UPDATED Dec 17 08:28:44 2018				
DRAWN	cap_array3			
CHECKED				
CHECKED				
CHECKED	SIZE D	CAGE NO.	DWG NO.	REV
ISSUED	SCALE		SHEET	OF

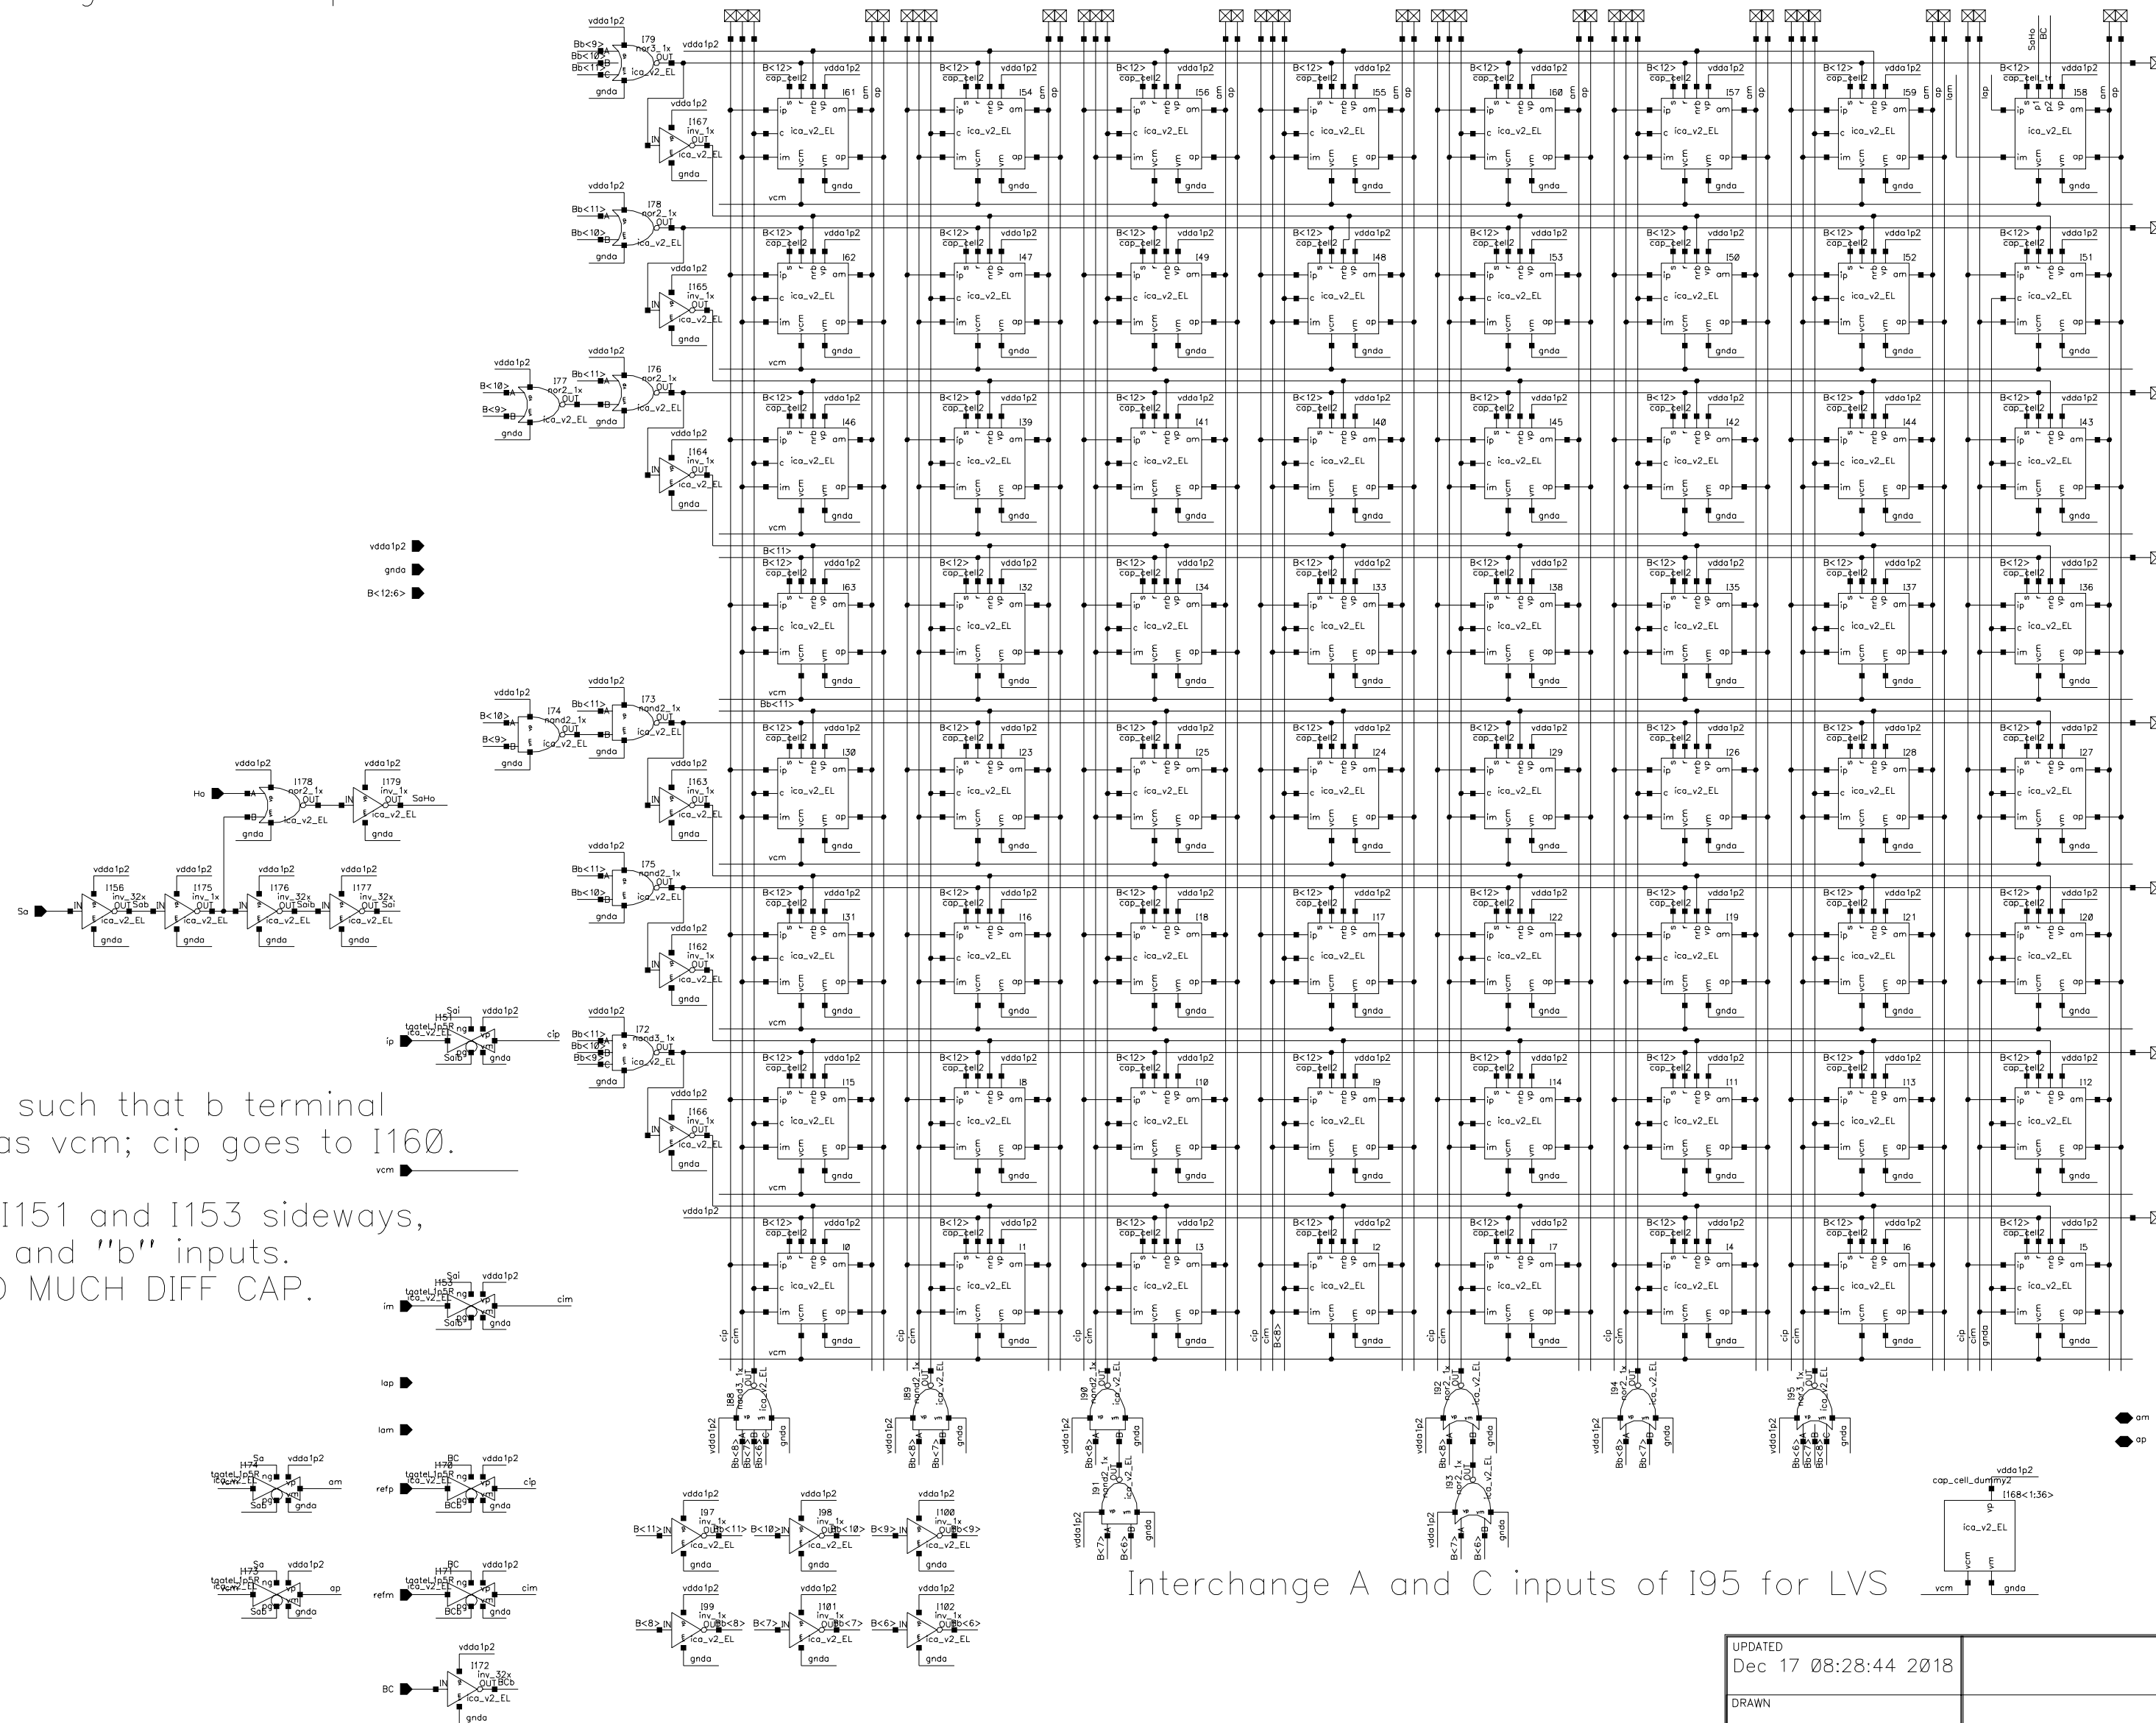
Interchange A and C inputs of I95 for LVS

LVS wants to flip I151 and I153 sideways,
interchanging "a" and "b" inputs.
TG layout has TOO MUCH DIFF CAP.
